Project Title
32 Well Walk

Sheet Title
PROPOSED Elevations

Date 06/02/2023	Sheet No. 2302-300
--------------------	-----------------------

2 Proposed Rear Elevation
300 Scale 1:50@A3

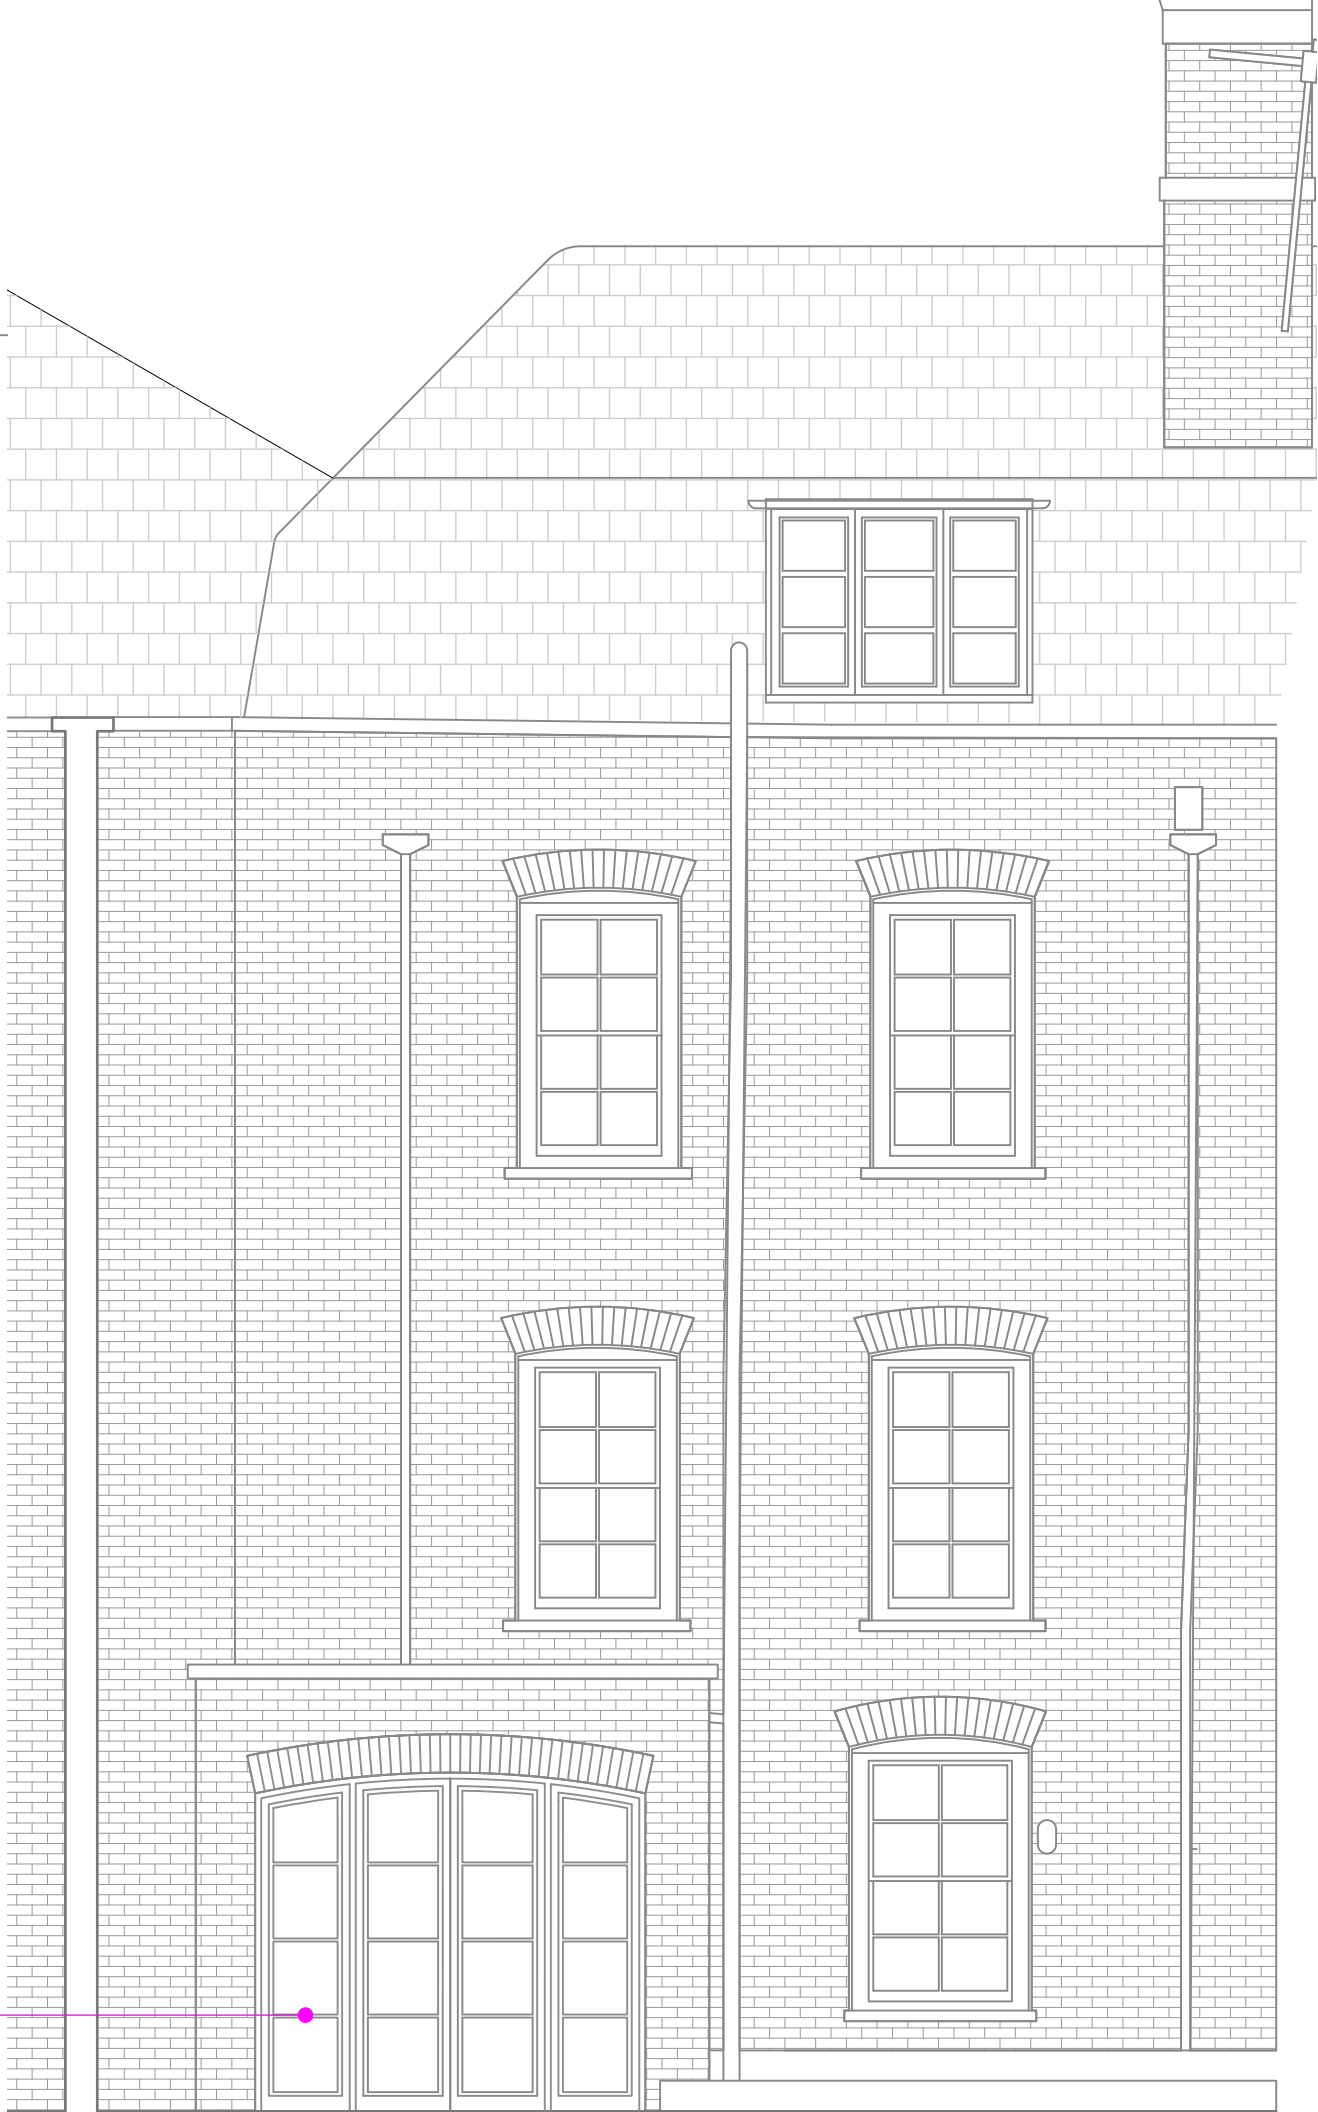
Rear extension opening design revised as per comments received from Henry Young by email on 19th August 2024
